**First Mining Gold (FMG) Response to the Impact Assessment Agency of Canada Comments on the Springpole Gold Project Environmental Impact Statement/ Environmental Assessment Received on February 10, 2025**

## **ATTACHMENT\_IAAC-WQI-01**

# **ATTACHMENT\_IAAC-FH-01**

## **ATTACHMENT\_IAAC-FH-03**

**Figure FH02.02:  
Development of Fish Abundance Benchmarks from Provincial Broadscale Monitoring Program Lakes**

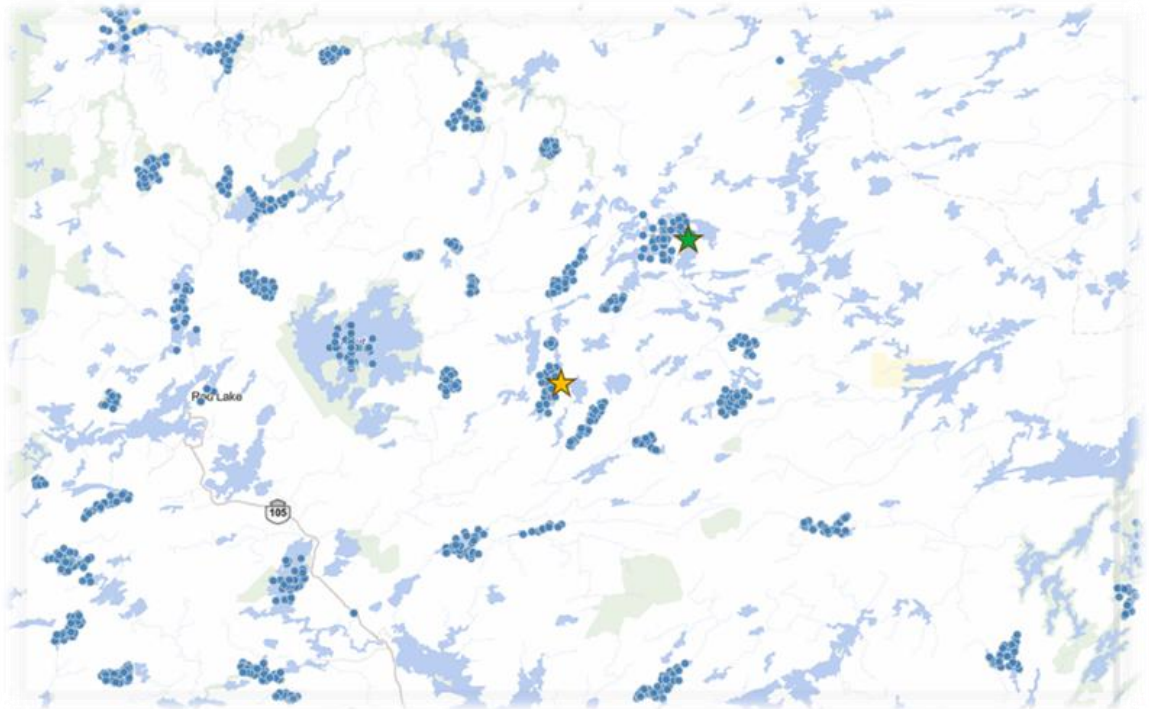
<b>Affiliated Comments</b>	<p><b>Information Request FH-02</b></p> <ol style="list-style-type: none"><li>1) Provide more detailed information on the proposed reclamation works at South Bay Mine, including the works required to reach the end goal of restored fish communities in Boomerang, Amanda and Mud Lakes.</li><li>2) Clarify the objectives of the South Bay Mine reclamation efforts with respect to benefiting fish and fish habitat.</li><li>3) Provide detailed information regarding the arrangements made with MINES for the South Bay Mine reclamation, discussing the proportion and types of works the Proponent will be contributing to, and the timeline and monitoring planned for the area.</li><li>4) Provide the MOU between the Proponent and MINES that is referenced in Appendix F, page 8-7, if not confidential.</li></ol>

<b>Fisheries Objectives:</b>	<p>The main objective of the South Bay Mine reclamation is to promote the biological recovery of three non fish frequented lakes (Armanda, Mud and Boomerang) such that they are capable of supporting fish communities. The recovery of the three lakes will result in an 87 ha increase in fish frequented waters. An additional objective is to reduce the ongoing impacts to the nearshore areas of Confederation Lake (e.g., zinc) documented in Armanda Bay, Mill Bay and Boomerang Bay as measured through water, sediment and biota.</p>		
<b>Fisheries Objectives Methodology</b>	<p style="text-align: center;"><b>Baseline Planning</b></p> <ul style="list-style-type: none"> <li>• Develop a current and robust data set of the existing conditions with measurable benchmarks.</li> <li>• Sample / confirm absence of fish in Armanda, Mud and Boomerang Lakes (due to low pH).</li> <li>• Sample baseline invertebrate community metrics following Environment and Climate Change Canada Environmental Effects Monitoring methods.</li> <li>• Sample lower trophic community (chlorophyll a, plankton) quarterly.</li> <li>• Sample sediment condition at depth (contaminant levels and grainsize) by core sampling.</li> <li>• Sample water quality at surface and depth seasonally.</li> <li>• Sample contaminants in fish invertebrates and plankton in Armanda Bay, Mill Bay, Boomerang Bay and reference sites in Confederation Lake</li> <li>• Develop reference baseline fish abundance benchmarks from adjacent reference lakes; and or from provincial Broadscale Monitoring data base (See Figure FH02.02).</li> <li>• Develop water quality model to predict lake recovery from available data and supplement with data collection as needed.</li> </ul>	<p style="text-align: center;"><b>Reclamation</b></p> <ul style="list-style-type: none"> <li>• Reduce the seepage from the South Bay Mine to the adjacent lakes using methods described below.</li> <li>• Monitor 21 wells (installed in circa 2015) and supplement as needed to establish rate and directions of improvement to groundwater.</li> <li>• Monitor surface water runoff for contaminant loading and flow rates.</li> <li>• Compare trends to pre-construction data and refine prediction of lake(s) recovery.</li> </ul>	<p style="text-align: center;"><b>Success Monitoring</b></p> <ul style="list-style-type: none"> <li>• Measure the increase in species presence and abundance of fish in Armanda, Mud and Boomerang Lakes. construction and post-reclamation. Use the benchmarks developed as part of the Baseline / Planning phase as success goals (See figure FH02.02).</li> <li>• Measure a reduction in contaminants in young of the year yellow perch (particularly zinc and manganese) from Armanda Lake, Mud Lake Boomerang Lake, Armanda Bay, Mill Bay, Boomerang Bay and reference areas in Confederation Lake. If perch are not available a second species will be determined.</li> <li>• Measure contaminants in plankton, invertebrates, sediments and water samples from Armanda Lake, Mud Lake Boomerang Lake, Armanda Bay, Mill Bay, Boomerang Bay and reference areas in Confederation Lake. Compare to pre-construction values, and assess improvement trends over time.</li> </ul>

Select Lakes from Provincial database. Preference given to lakes that have multiple BsM Cycles (2-3) representing a 10 -15 year period.

Calculate the Area-Weighted CPUE / BPUE for each BsM Cycle (all Species) as per MNR protocol.

Statistically determine mean values by species with confident intervals as benchmarks for the reclaimed lakes. Some grouping of data may be necessary to reflect lake size, depth and trophic status comparable with the Project lakes.

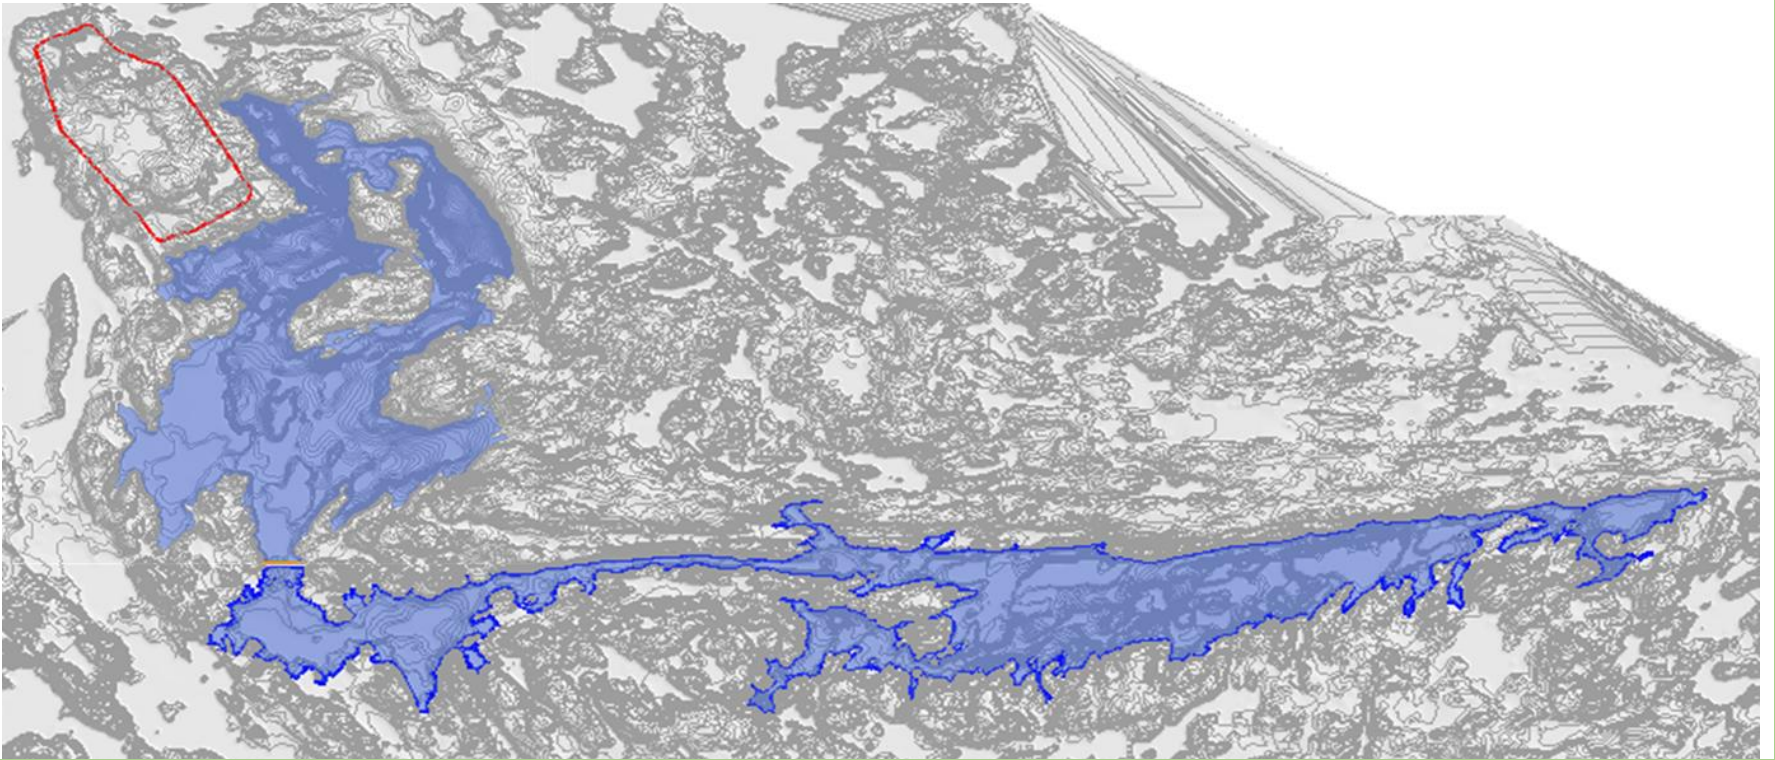
2. In Section 6.10 of the EIS, the Proponent states that non-schooling fish tend to occupy depths of 18 to 25 m (defined as pelagic habitat). Provide the proportion of 18 to 25 m habitat within NB-01 compared to the remainder of 18 to 25 m habitat in Springpole Lake and provide the proportion of 18 to 25 m habitat that will be created after the pit has been restored compared to the remainder of 18 to 25 m habitat in Springpole Lake. If the quantity of 18 to 25 m habitat is higher after restoration, some credit may be considered offsetting for the surplus lake trout habitat, assuming the remainder of the pit is restored as currently proposed.

As requested, an analysis of lake proportions was completed to compare the existing Springpole Lake with the proposed reclaimed Springpole Lake at closure. The 18 m to 25 m is recognized as an important pelagic habitat for Lake trout, Lake Whitefish and other large bodied species seeking summer thermal refugia. Notwithstanding this being the depth range where most cold water fish were observed, fish were also observed and captured below 25 m to greater than 30 m providing the dissolved oxygen was suitable. We have used 30 m depth as the lower limit of this analysis as it is consistent with the depth of observed fish usage, and it is within the range of depths that the reclaimed open pit basin modeling has predicted lake mixing and the aerobic conditions.

As shown in Tables A and B, only a portion of the deep water habitat will be temporarily isolated by the open pit basin, with the majority of the deep water habitat remaining in the main lake. There will be a large increase in pelagic habitat volume as a result of the reclaimed open pit basin, in the order of a 260% to 550% increase within the reclaimed basin itself, and a 56% to 158% increase for the total lake volume. The increase volume at the depth is coupled with a corresponding increase in the planar area of these depth intervals. Table A also shows that the majority of the deeper pelagic habitat between 18 m and 25 m and between 25 m and 30 m in the existing lake will be retained within the remainder of the North Basin until project closure and reclamation of the Open pit basin.

To respond to the specific comment in Information Request FH03, the reclaimed open pit basin will result in a net increase in 18 m to 25 m pelagic habitat by 7.4 Mm<sup>3</sup> and an increase in the 18 m depth contour by 98 ha, and an increase in the 25 m depth contour by 112.9 ha. We suggest further discussion with DFO to determine potential additional credit that may be attributable to the Project as an offset measure for the increased values.
